Our Ref: 59919086- L03A: BCP/bcp  
Contact: Dr Brett C. Phillips

2<sup>nd</sup> September 2022

**RESPONSES TO NORTHERN BEACHES COUNCIL UNRESOLVED ISSUES FOR  
DEVELOPMENT APPLICATION NO: DA2021/1912, 2-4 LAKESIDE CRESCENT &  
389 PITTWATER ROAD, NORTH MANLY, NSW**

**Figure 1 Flood Risk Precincts**

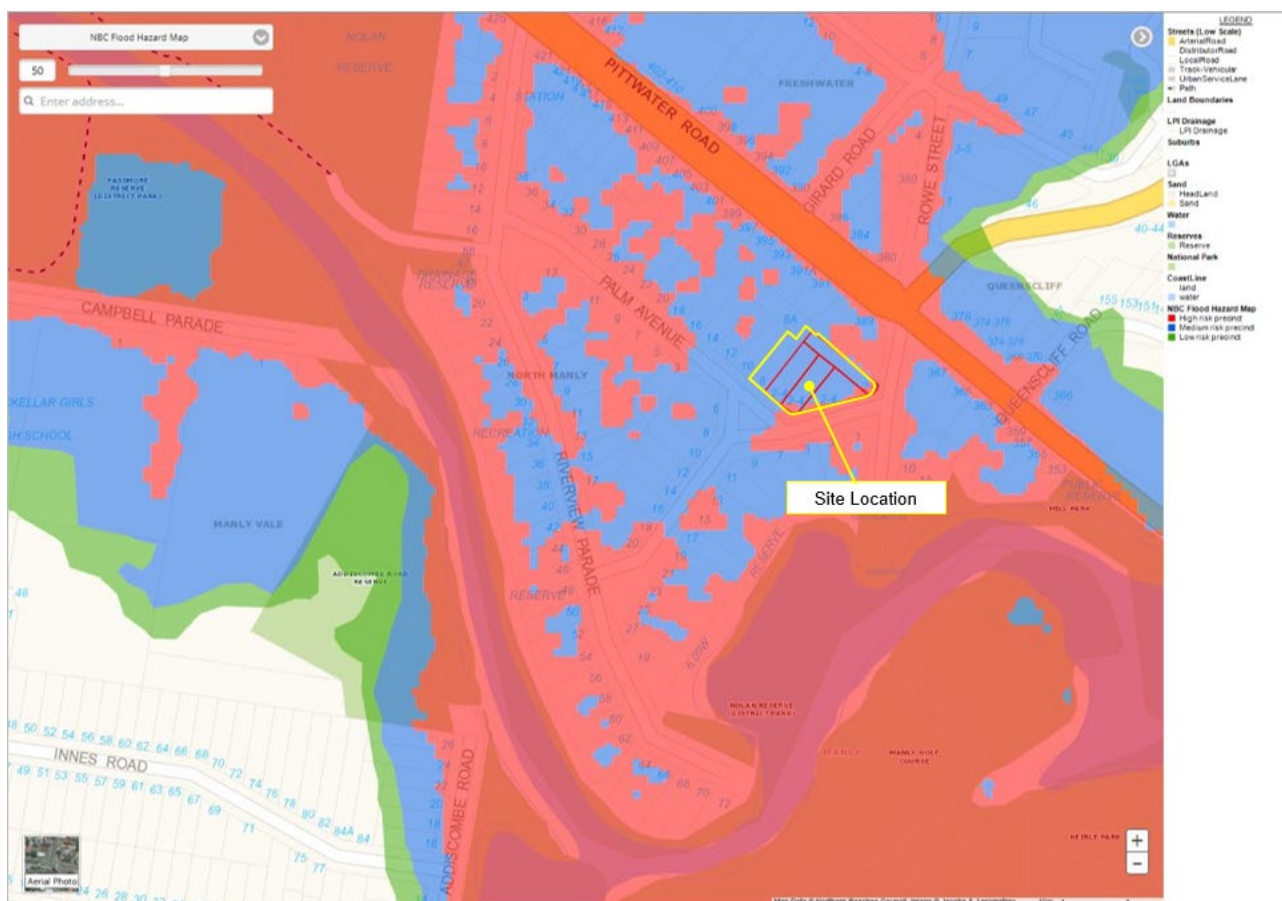
*The response (dated 15 May 2022) to the flood referral comments has been assessed. The ground floor of the former Queenscliff Community Health Centre has considerable flood risk.*

It is unclear how Council has defined “considerable flood risk”. The existing building which is to undergo adaptive re-use is located in a Medium Risk Precinct (based on Council’s own mapping of Flood Risk Precincts which considers the severity and likelihood of flooding experienced across the floodplain).

**Figure 2 Ram Push-Up Flood Barrier Details – Courtesy Flooding Solutions Pty Ltd**

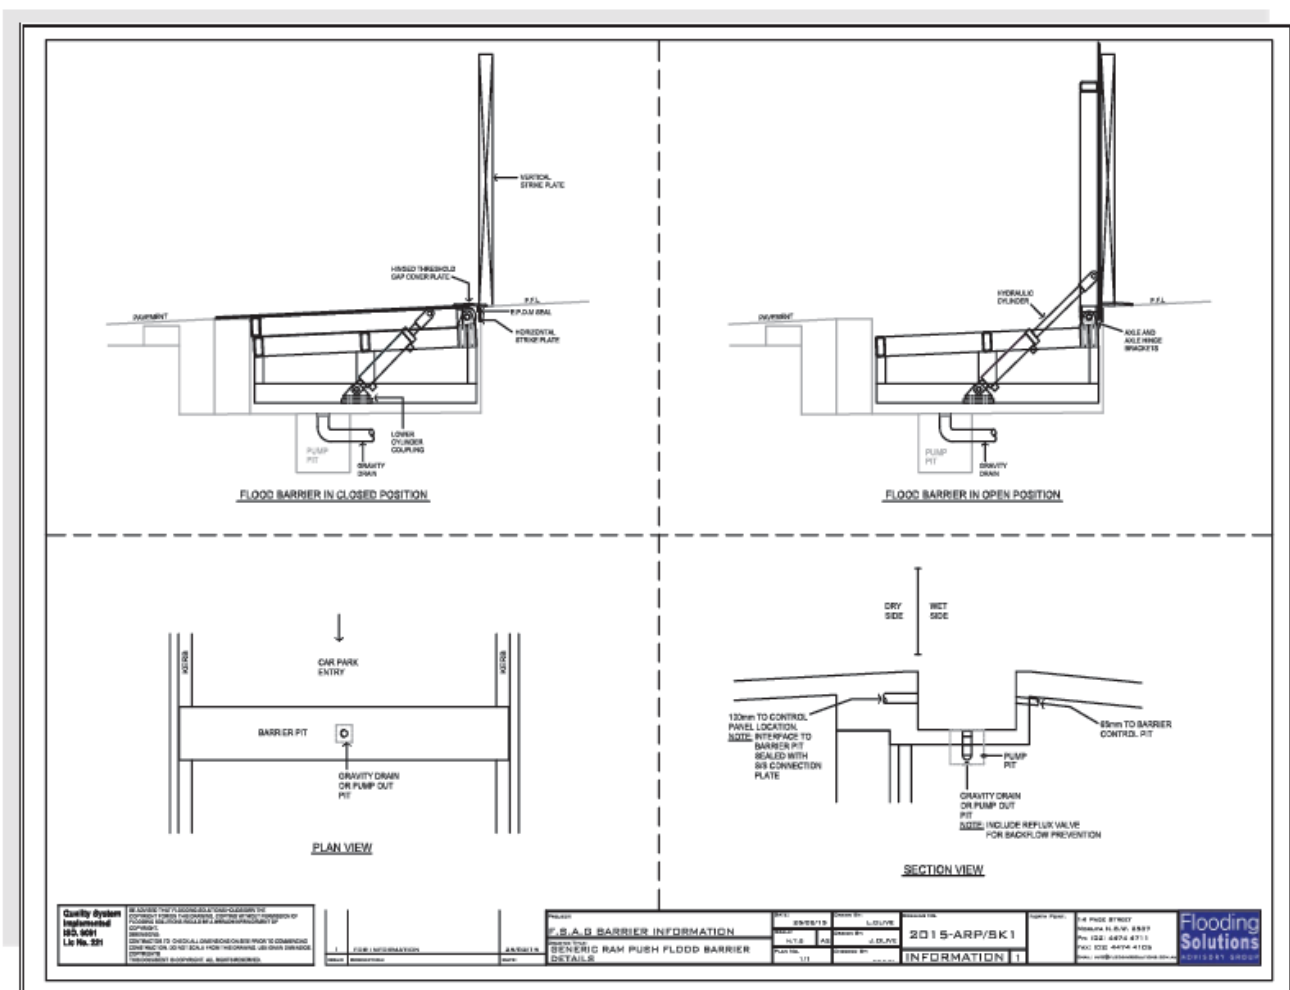
An alternative to flood doors might be for flood barriers to be installed to exclude flood waters entering the ground floor.

If the doors are outward opening (for fire), then any flood barriers would need to be located just inside the doorways. The most suitable barrier would likely be a reverse ramp push-up barrier. Examples of this barrier are given in **Figures 2, 3 and 4**.

It is noted that a 0.7 m high flood barrier would protect any entries up to and including the Flood Planning Level.

A further consideration is the floor type at each external doorway and the feasibility of incorporating the flood barrier system into the floor.

Figure 5 Concept Internal Ramp

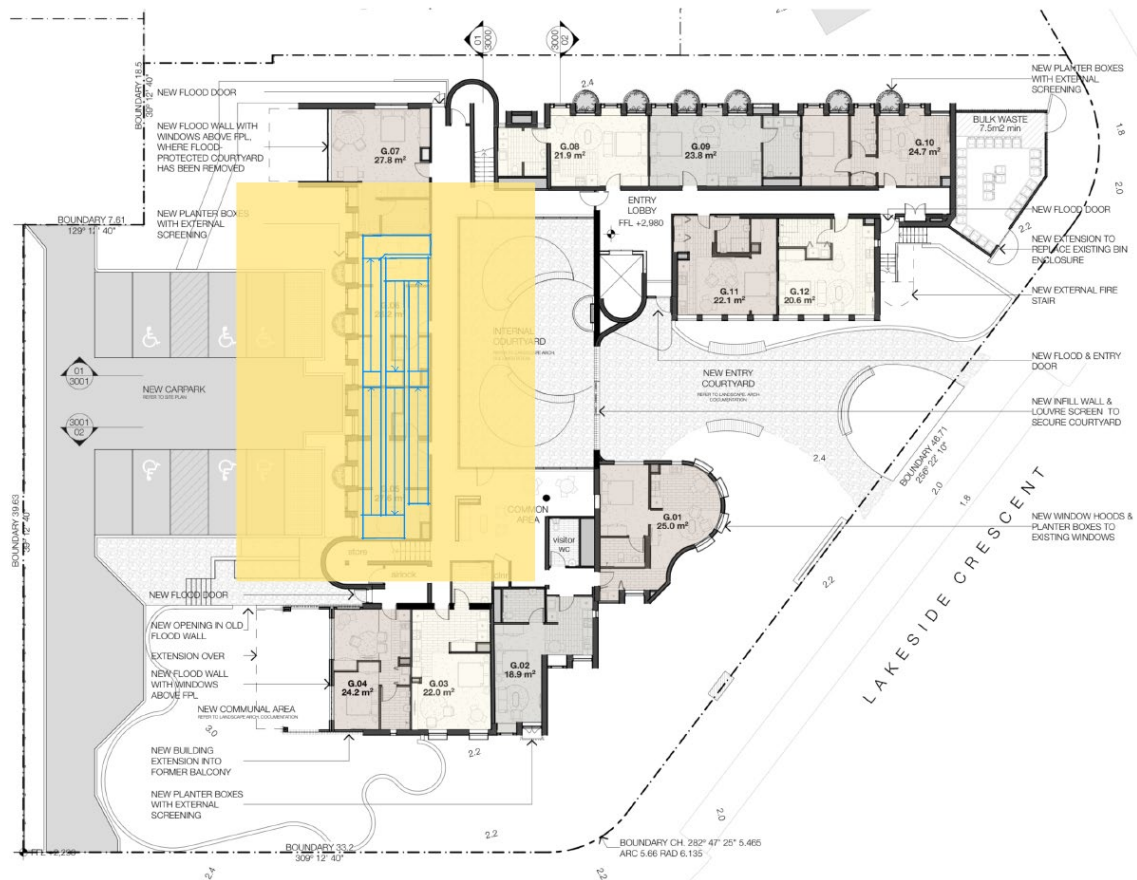
*For senior housing, as a minimum there must be a ramp accessible from the ground floor to the shelter in place refuge. Battery powered stair lifts and flood wardens are supported, however they would be needed along with a ramp. If a ramp is not possible, then seniors living is not deemed an appropriate development use*

The feasibility of providing a ramp either external to the building or internal to the building has been assessed.

Conceptual layouts of an external ramp and an internal ramp have been formulated by Integrated Design Group and are given in **Figures 5 and 6**.

It is concluded that neither an internal ramp nor an external ramp is feasible based on appearance, cost and impact.

It is further concluded that an internal ramp or an external ramp is unwarranted given the building is located in a Medium flood risk precinct and the hierarchy of evacuation methods which will be implemented to evacuate residents from the Ground Floor to the refuge area on Level 1 at the time of major floods.
